**2011 Planning
Commission**

**RE: Architectural Review of Parking Garage F-1
and Phase I, Tysons Corner Center, Macerich,
per proffers executed with RZ/FDP 2004-PR-044**

ARCHITECTURAL REVIEW OF PORTIONS OF PHASE 1 OF TYSONS CORNER CENTER
(MACERICH)

TYSONS CORNER CENTER PHASE 1:
OFFICE ARCHITECTURE & ROUTE 123 WALL / LANDSCAPING

Phase I Illustrative Landscape Plan

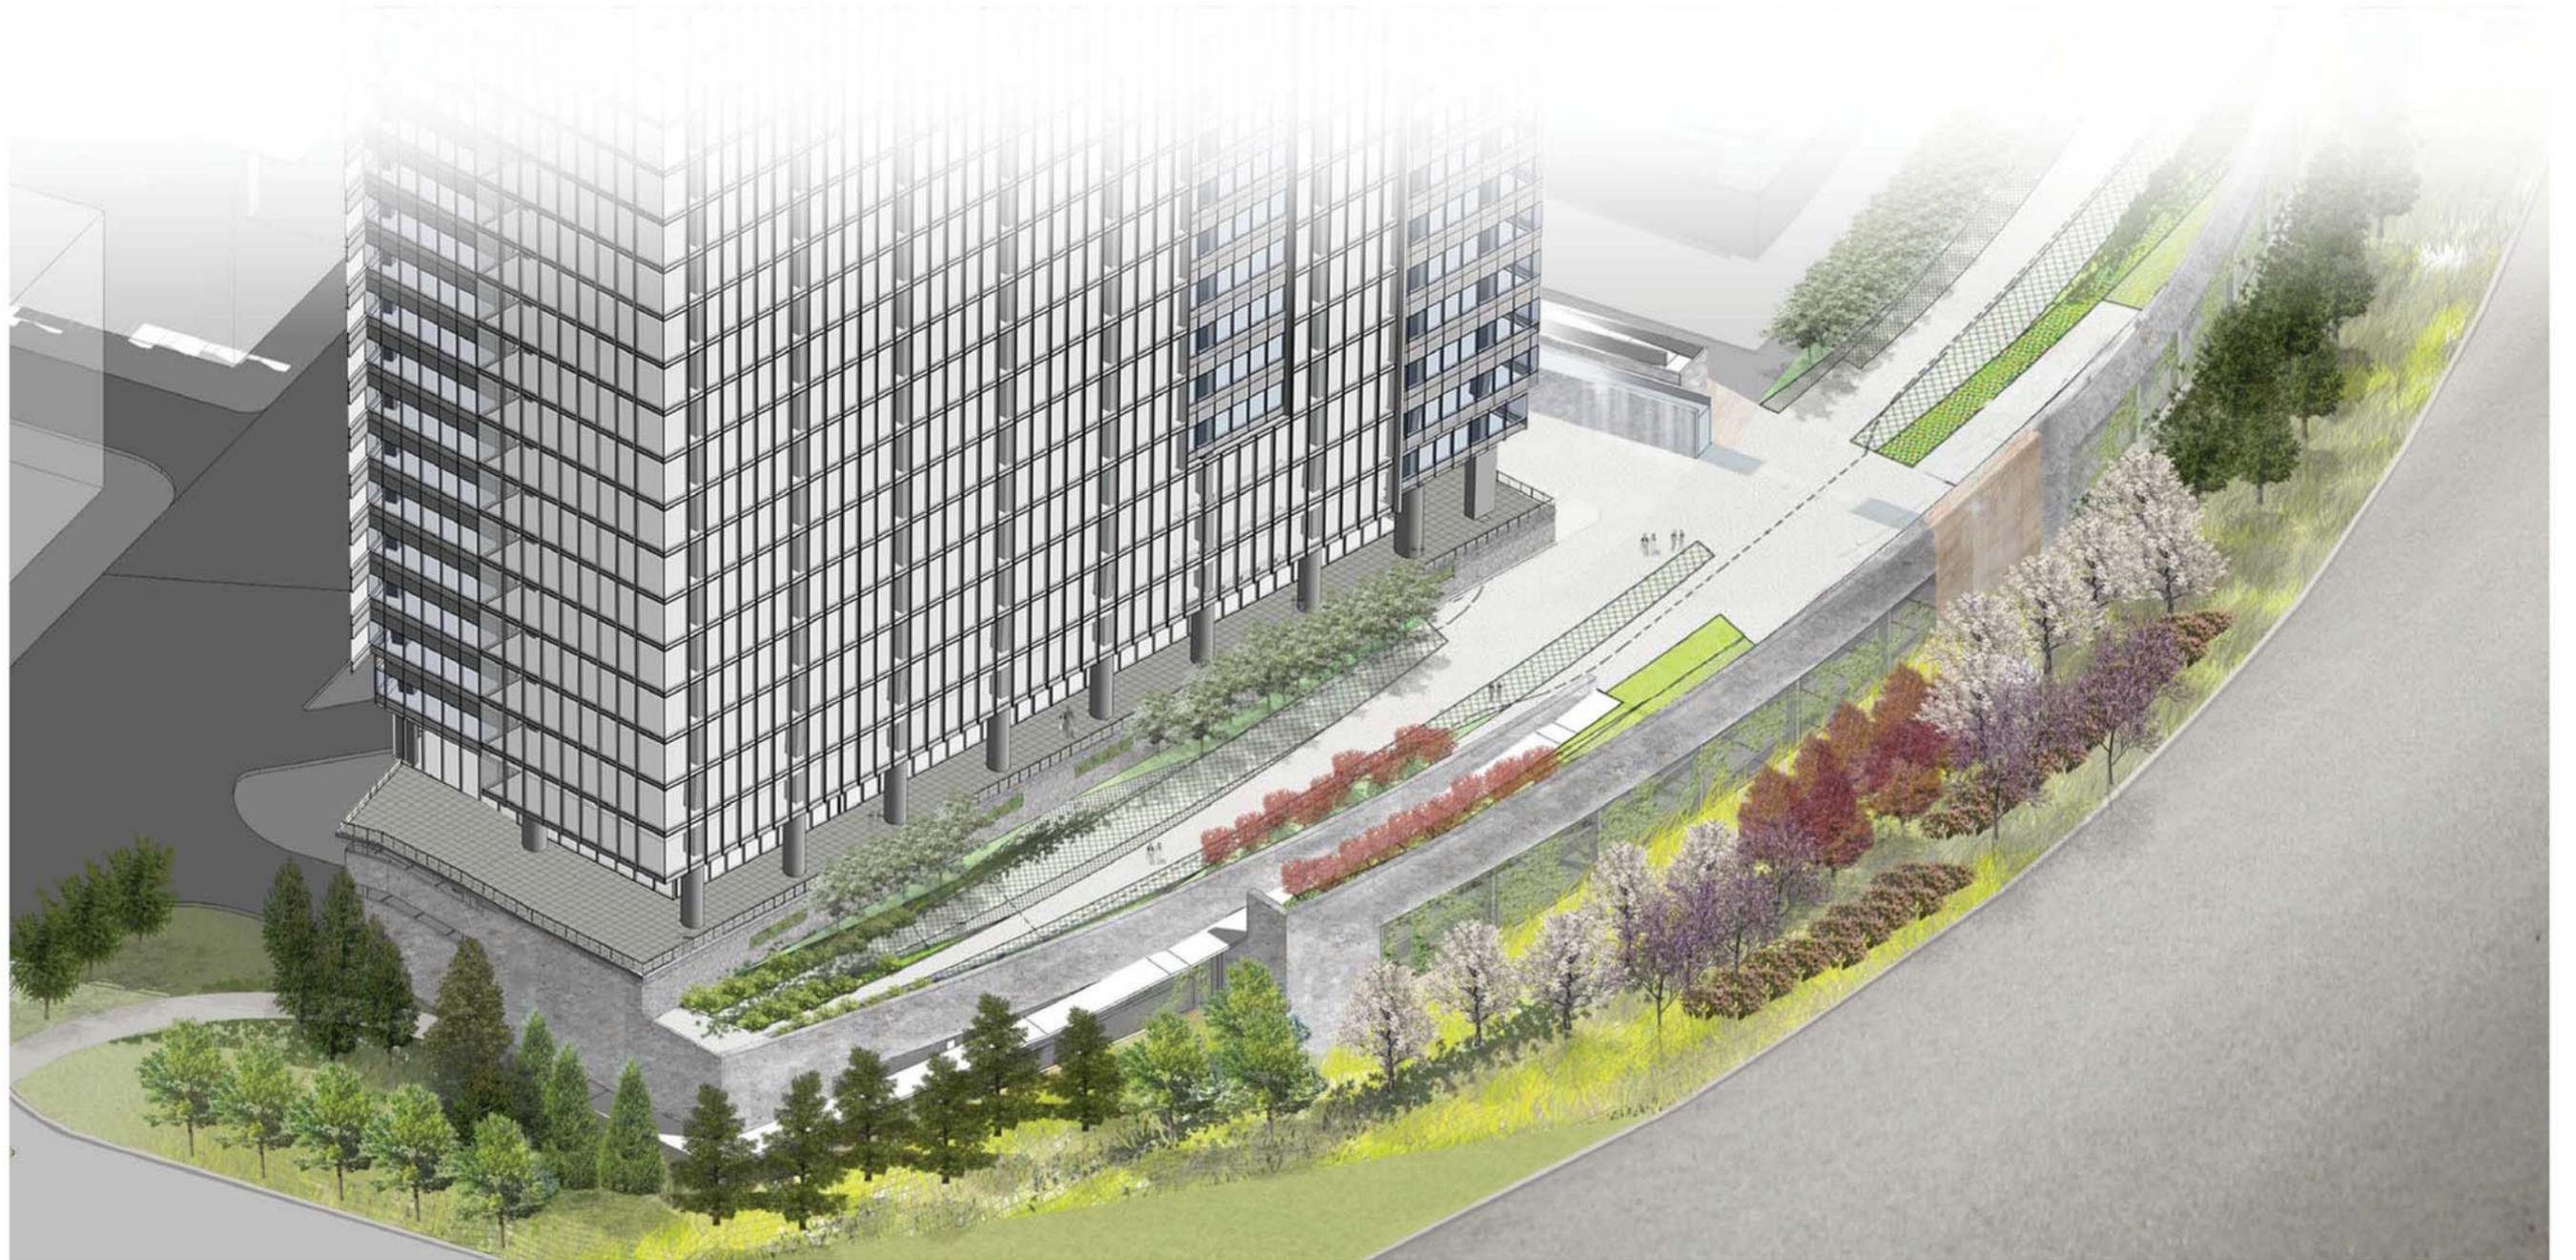
Commissioner Flanagan: On page 14 of your presentation, you show a green roof. But there's very little in the text that explains what's occurring in that space and there seems to be about – more paved surface up on the roof than there is green roof.

Commissioner Flanagan: I would like to know, you know, why you arrived at the square footage that you are going to have up there and what the – the landscaping plan shows all the plants at the ground level, but there's nothing about what's producing the green up on the green roof.

Ms. Zahm: Oh, okay. Oh, oh. Hillary Zahm with Macerich. On Sheet 18, you'll see a great deal of landscaping shown. I just want to mention that while some of that landscaping isn't grade, a significant portion of it is actually on our parking podium. So there actually are – there's more than one green roof here. And this is probably more likely where you'd throw a ball and hopefully you wouldn't throw it out onto Route 123, but that gives you a lot more open space – more usable open space for the public.

Mr. Krieger: Sure, that's a good – fair question. On the green roof we've specifically targeted the southern exposure. We've done a lot of green roofs in the area and find that we get the most success in the southern exposure when they have direct sunlight. So that specifically addresses why we put mechanical equipment on the north side of the penthouse and kept the green roof on the south side of the penthouse. Some of the areas are required around the green roof just to get to façade access for maintenance and window washing and cleaning, and we're specifying a product that comes in a roll of sheets. And it's just – it's a Sedum product. And it just has a mixture of wild flowers and seeds and it serves as a – it helps us retain water in these specific areas with these more wild flowers. And we've had a lot of success with that in the past as opposed to trying to specifically landscape just more specific things like shrubs and specific flowers and plants.
